CONSTRUCTION PLANS FOR CARRIAGE MEADOWS SOUTH AT LORSON RANCH

STREET, STORM SEWER, AND POND CONSTRUCTION PLANS

COVER SHEET
STREET, STORM SEWER AND POND
CONSTRUCTION PLANS

DATE: MARCH, 2017
 PROJECT NO. 100.030
 SHEET NUMBER **C6.18**
 TOTAL SHEETS: 37

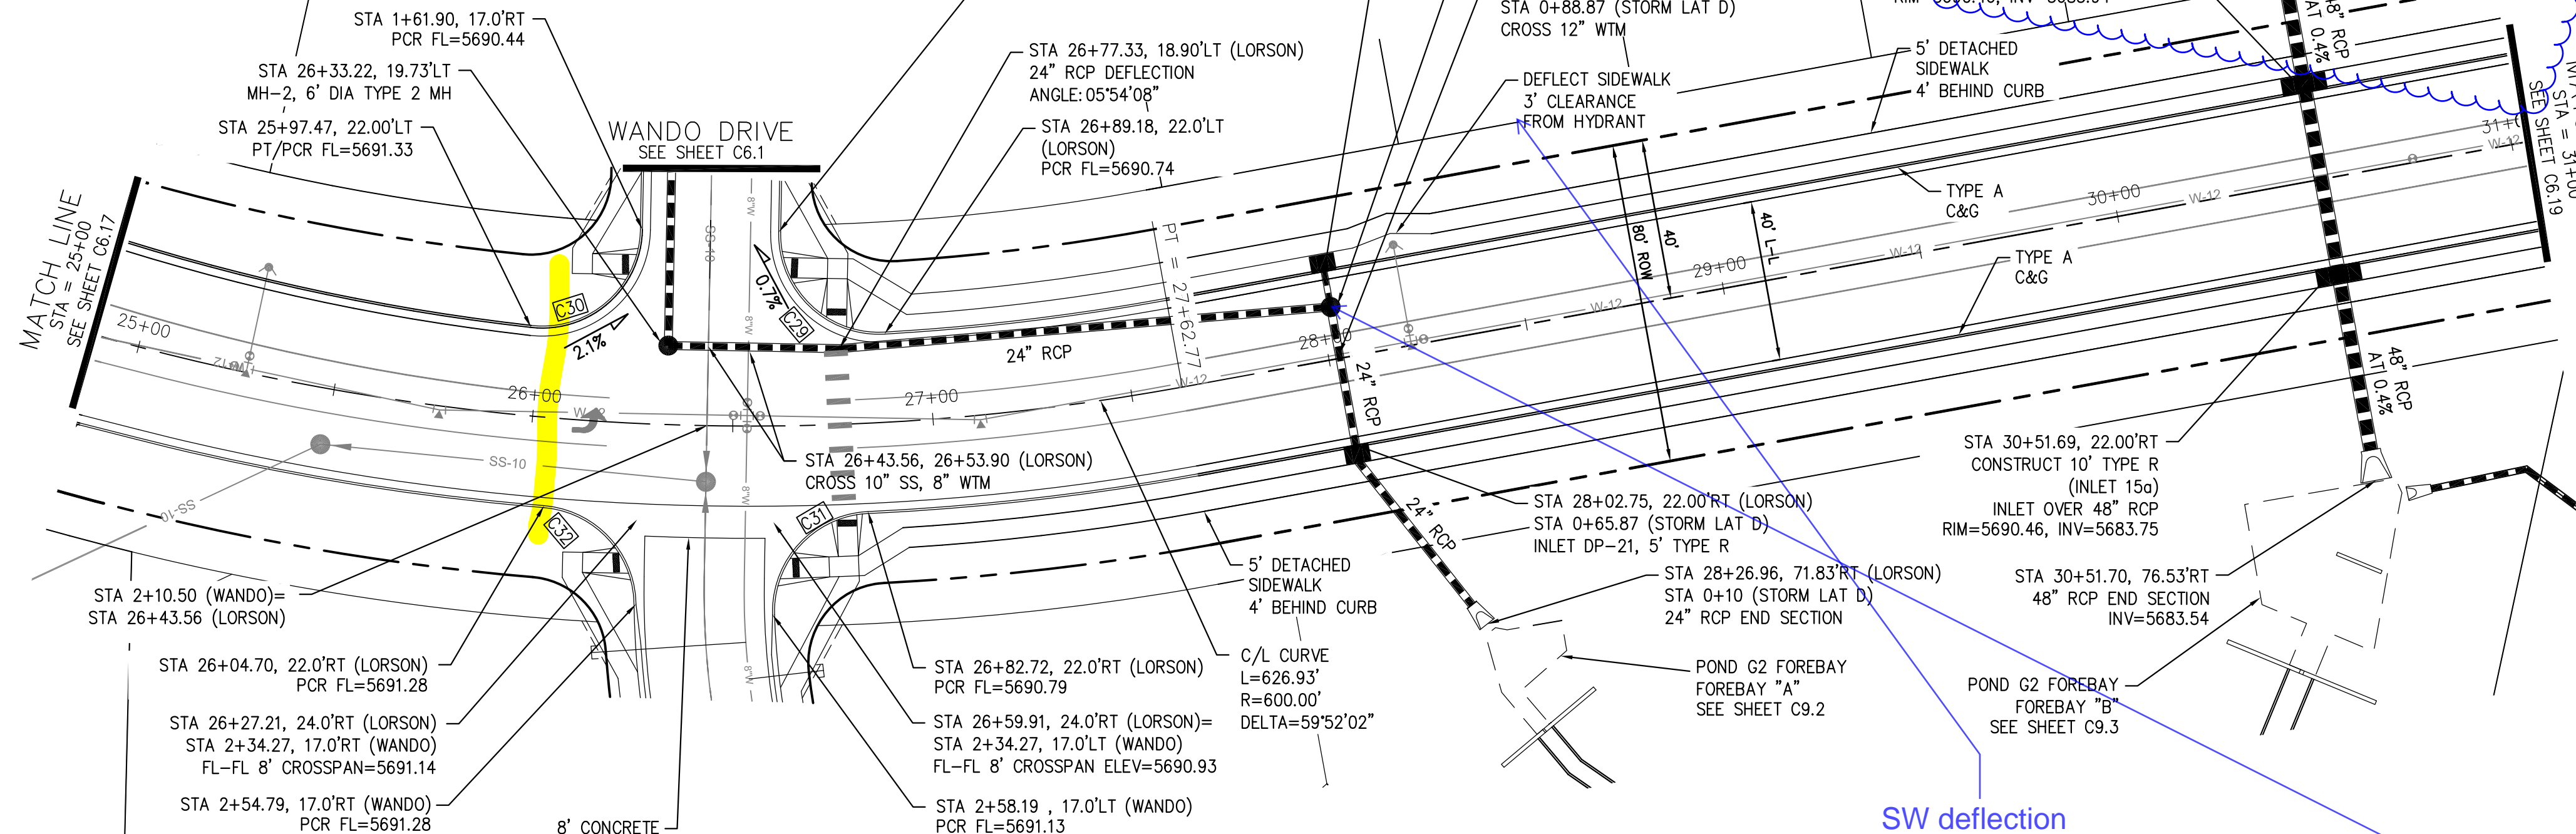
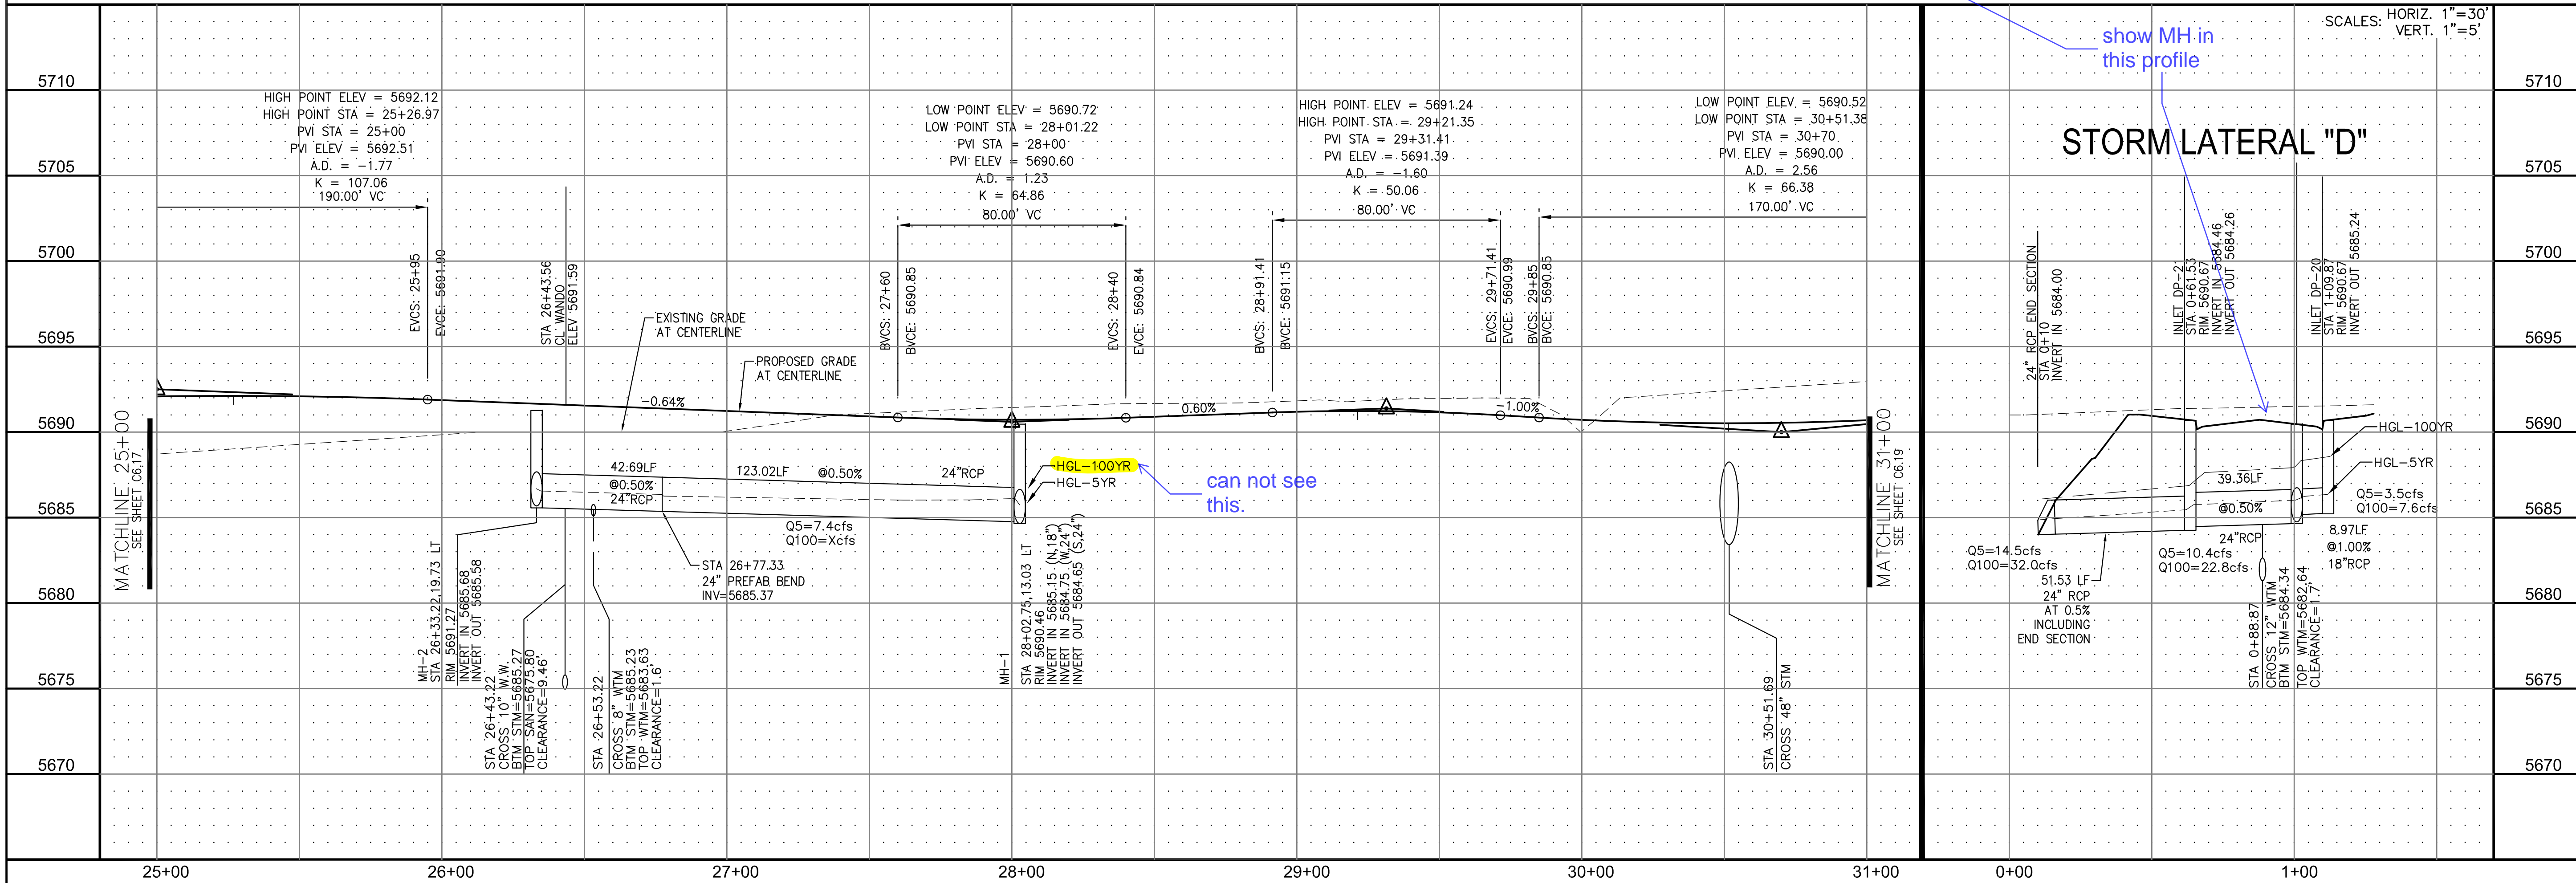
show lot numbers for clarification of where easement is required

show MH in this profile

can not see this.

DATE: MARCH, 2017
PROJECT NO. 100.030
SHEET NUMBER C6.21
TOTAL SHEETS: 37

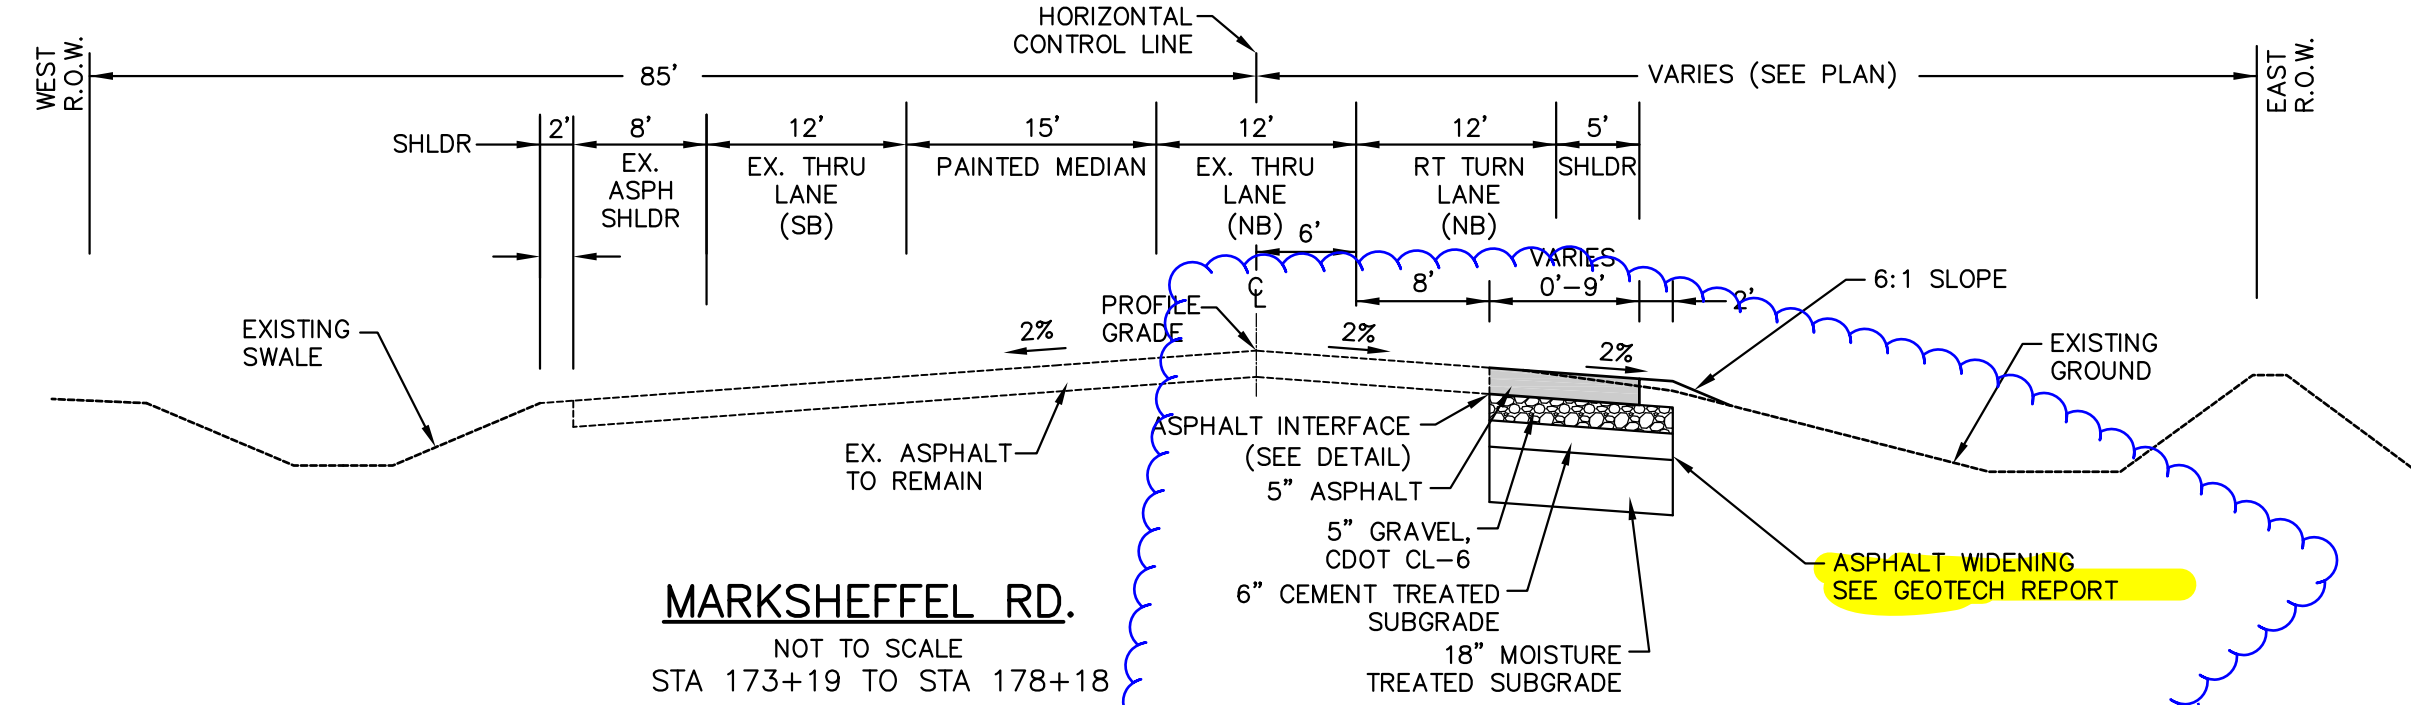
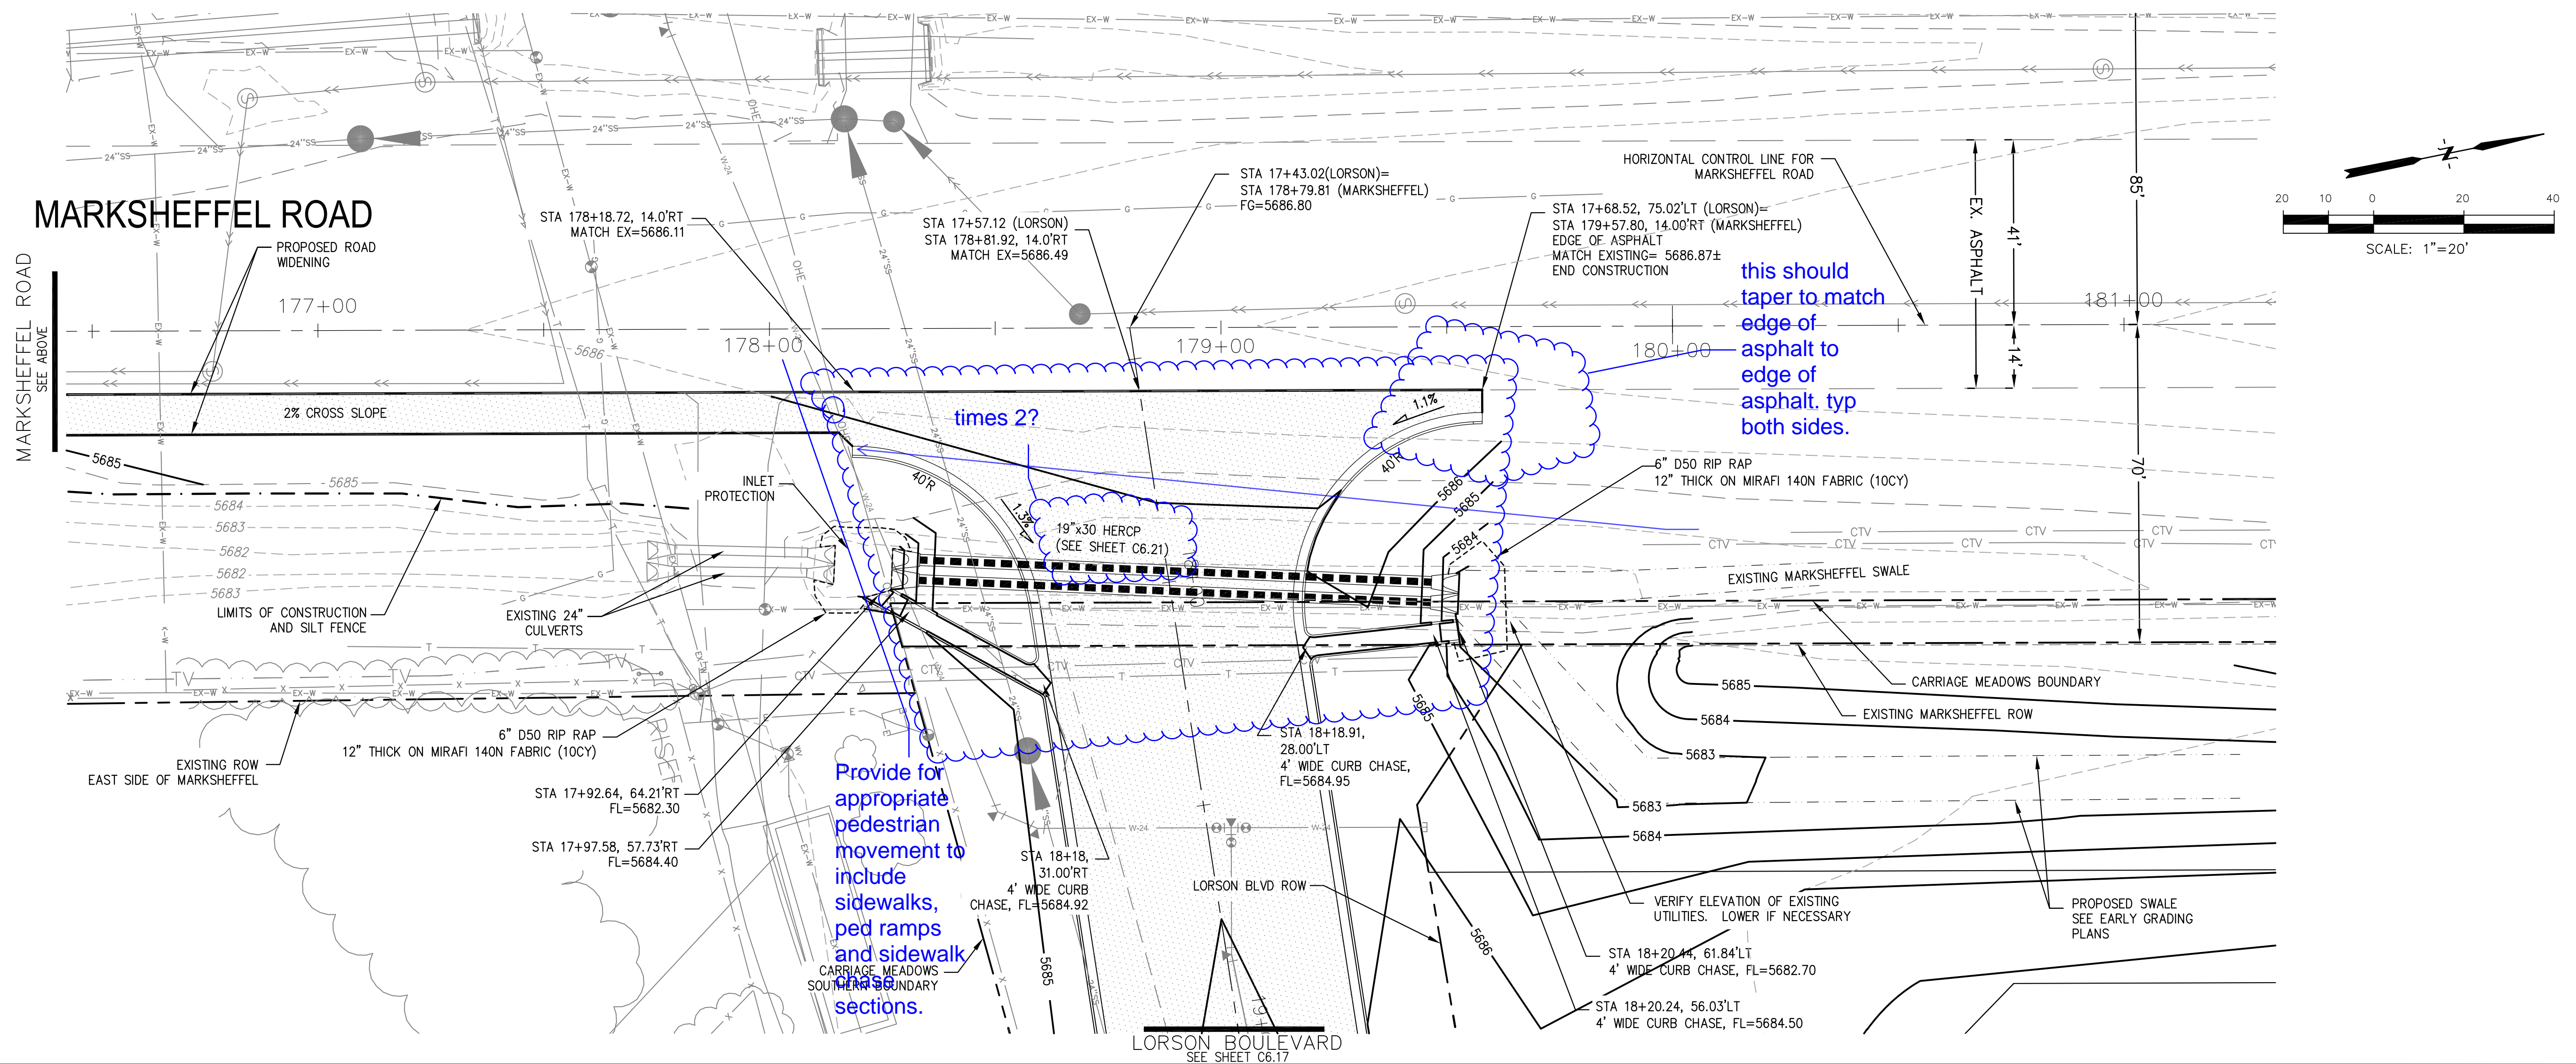
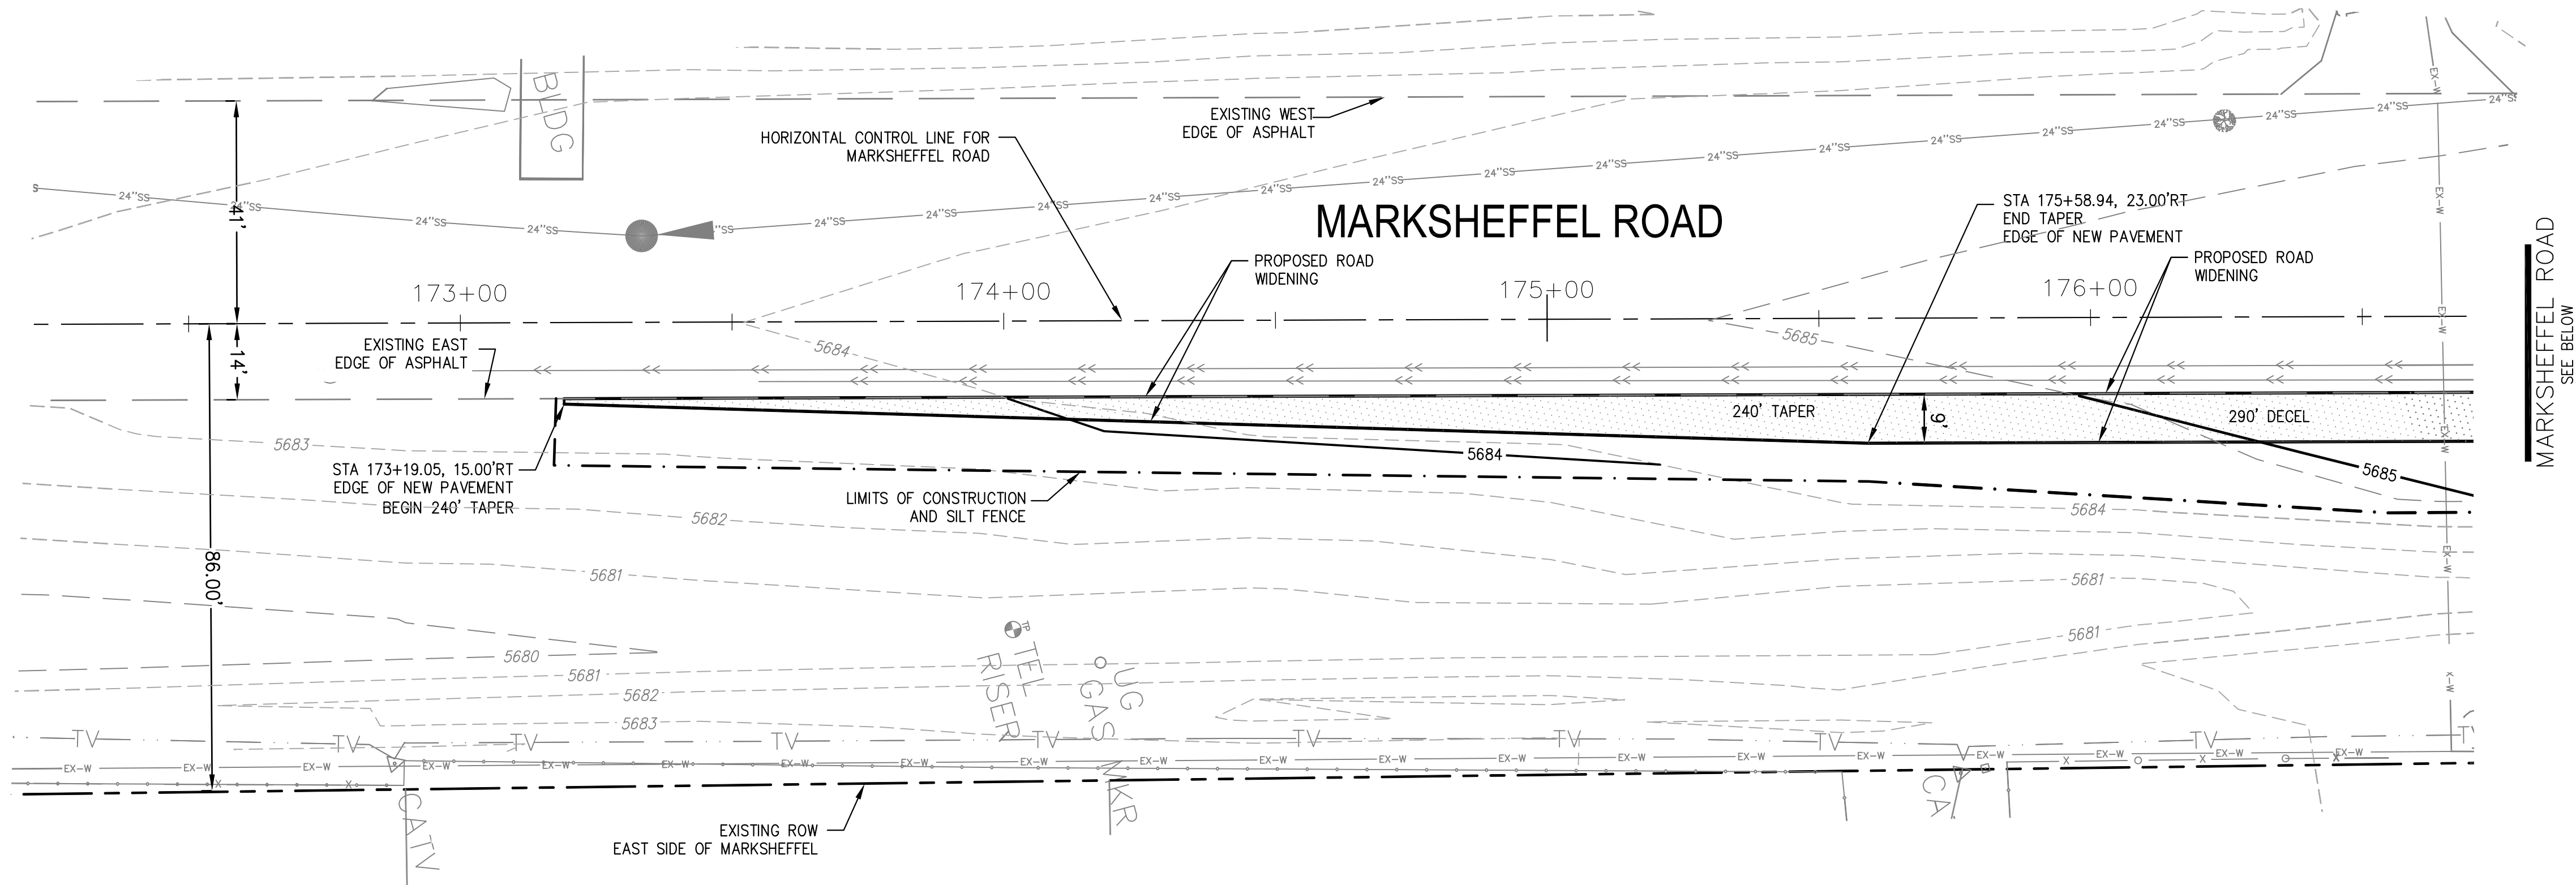
i do not believe i have this yet? Please call out by who and date on front of report. Please provide a copy.

Please provide appropriate erosion protection at each end per ECM.
